This drawing has been prepared as an update/revision to the previously approved planning/listed building submission with reference numbers: 16/00061/LB and 16/00060/F.
Following local authority approval of the above noted applications any planning/listed building condition clearing application was submitted and approved under reference number: 16/00250/DISC.
During the construction two minor elements were changed, we are submitting this application to gain consent for these minor changes, due to this being a listed building application minor amendments need to be dealt with as a full planning submission.

Rev.	Date	Revision Notes
Retrospective Update		
 STABLE ARCHITECTURE JEREMY DUNN 17 FIR TREE CLOSE BANBURY OXON OX16 1JS MOBILE 07710 461860 TELEPHONE 01295 270565 E mail: Jeremy.Dunn@Virgin.net		
Job: Renovation and Extension Yew Tree House Sibford		
Client: Mr & Mrs Mallows Yew Tree House Sibford		
Drawing No: 6033-01	Date 28/9/17	Scale As indicated@A1

East Elevation-Boiler Flue
1 : 100

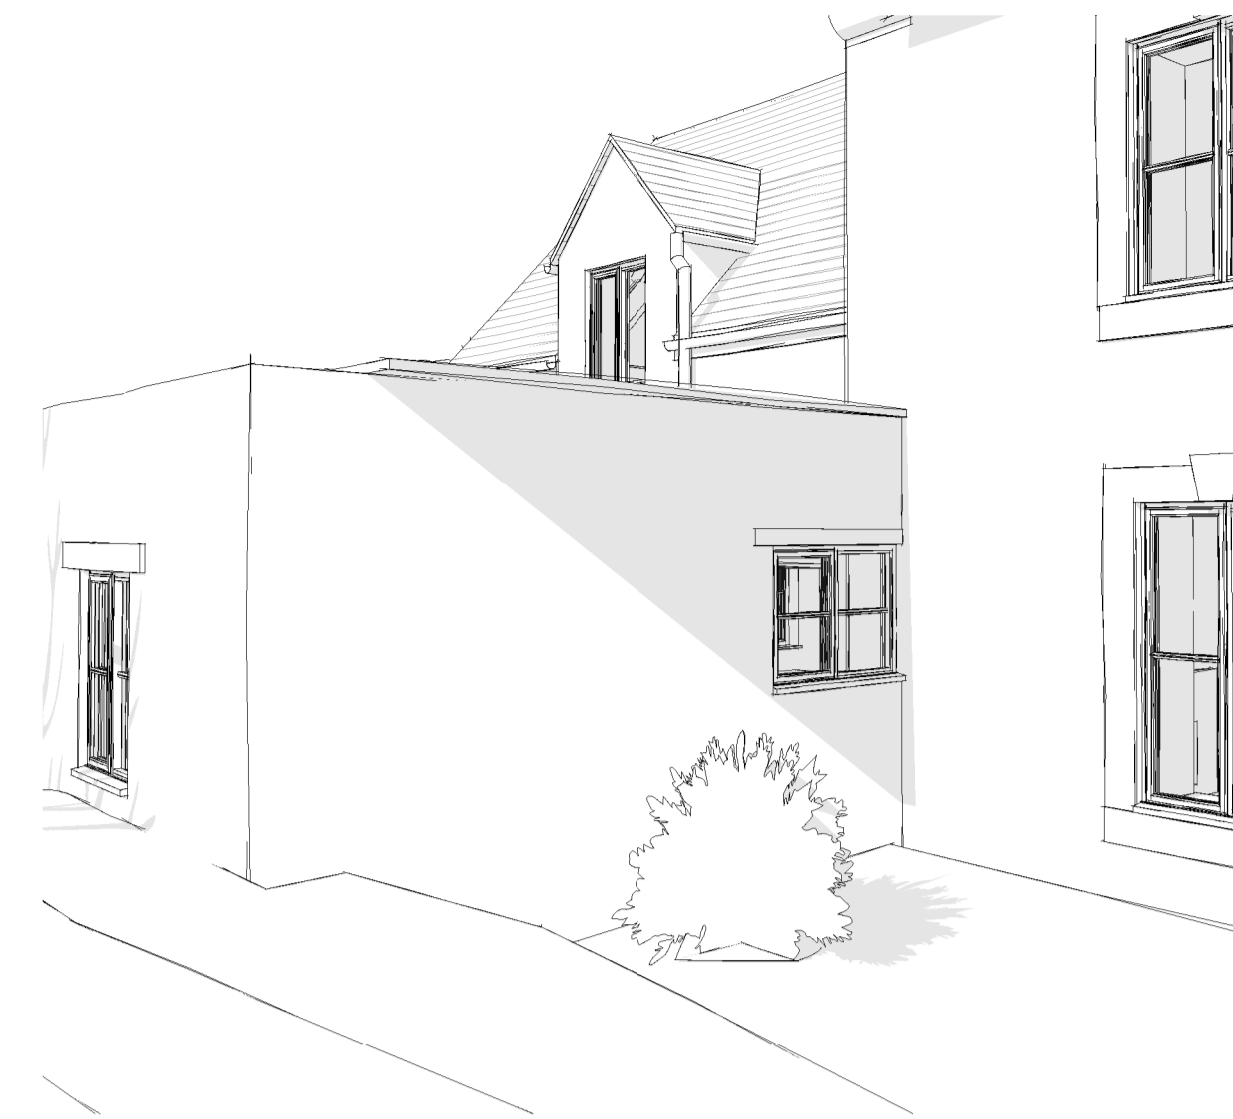
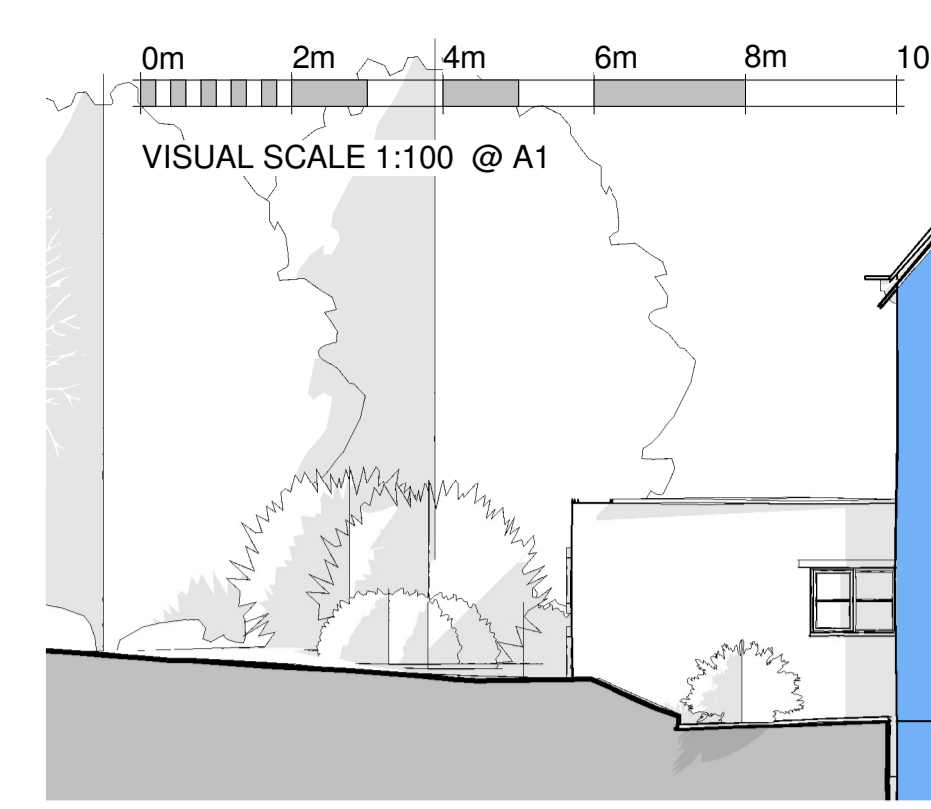
1 Boiler extract flue insertion within stonewall

the boiler was repositioned to this location as part of the revised drawings for the condition clearing application, however retrospective consent is sought for the penetration of the flue through the existing stonewall

- 1 The proposed boiler was moved to the position as now shown indicated with a balanced flue taken through the existing wall and terminated with a grill/guarding system in compliance with building regulations.

West Elevation - Revised Window
1 : 100

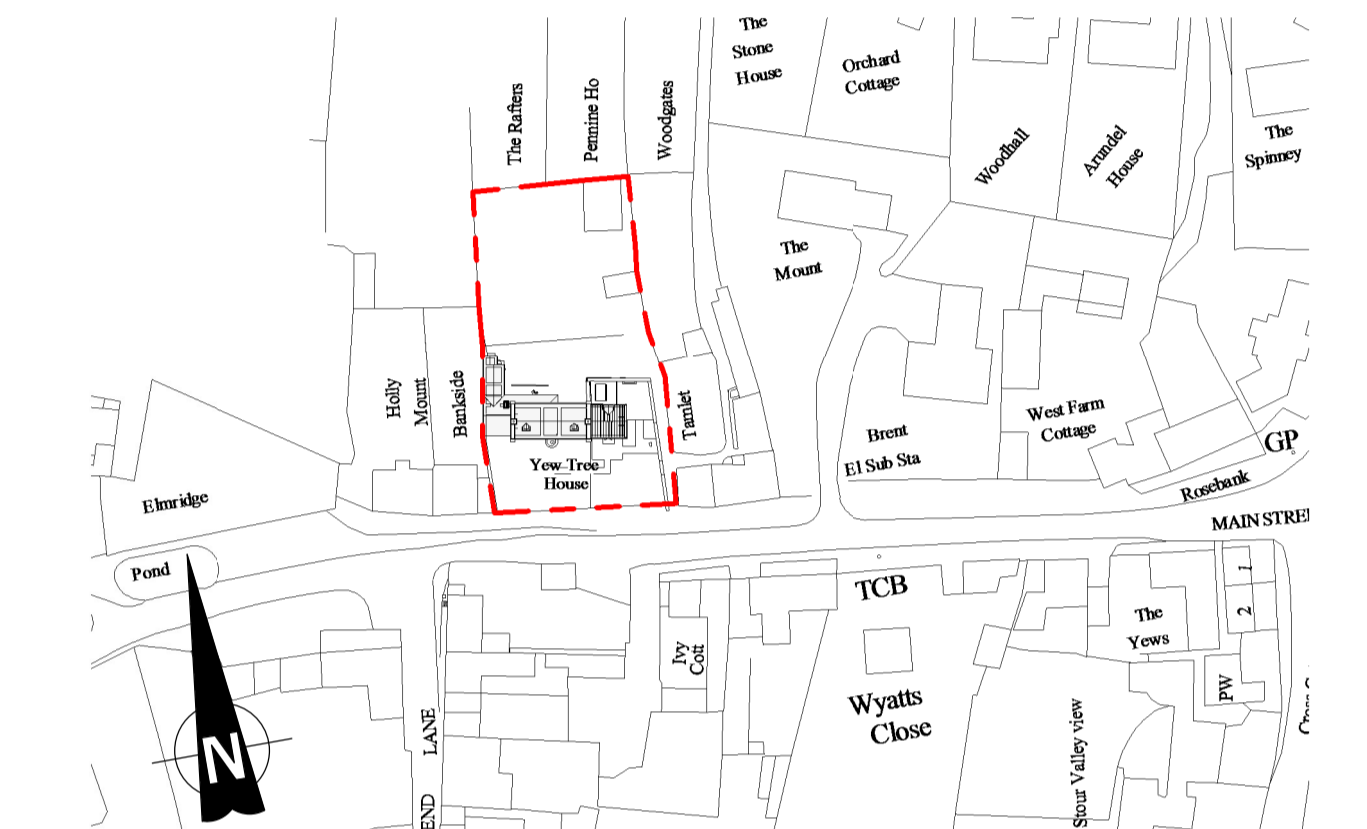
2 Window installed within wall rather than previously approved door installed within wall

- 2 A back door was approved on the initial scheme entering from the kitchen into the rear garden, this wasn't installed as approved and was changed to a window with a style to match existing.

a window was inserted into this opening as shown here instead of a door that was previously approved for this opening

South Elevation - Approved Double Door
1 : 100

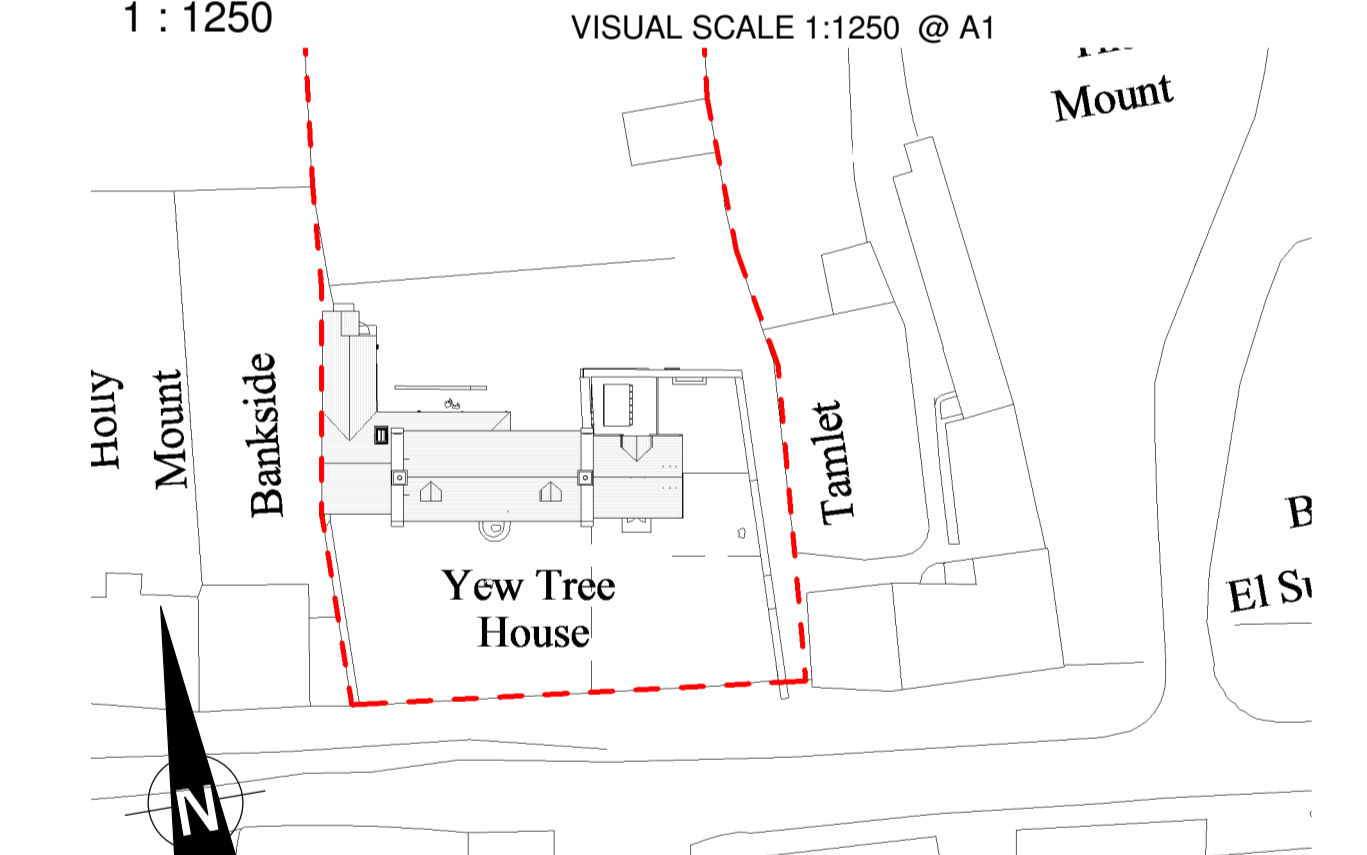
3 South elevation of kitchen extension showing single double door as approved under condition clearing, this is a revision to the planning approved elevation

- 3 A pair of doors were shown on the south elevation of the kitchen extension on the original approved drawings, however during the condition clearing application the listed building officer requested these be changed to a single french door. There was no request to update the approved drawings at the time and therefore the original planning approval elevations conflict with the condition clearing drawings. We have therefore taken this opportunity to change the door arrangements on the south elevation to the approved single door as shown on the condition clearing application.

the original planning approved drawing showed a pair of double doors within this elevation, however this was superseded by details approved as part of the condition clearing application, therefore this single door as shown here is as per the approved condition clearing plans and are shown here for clarification purposes
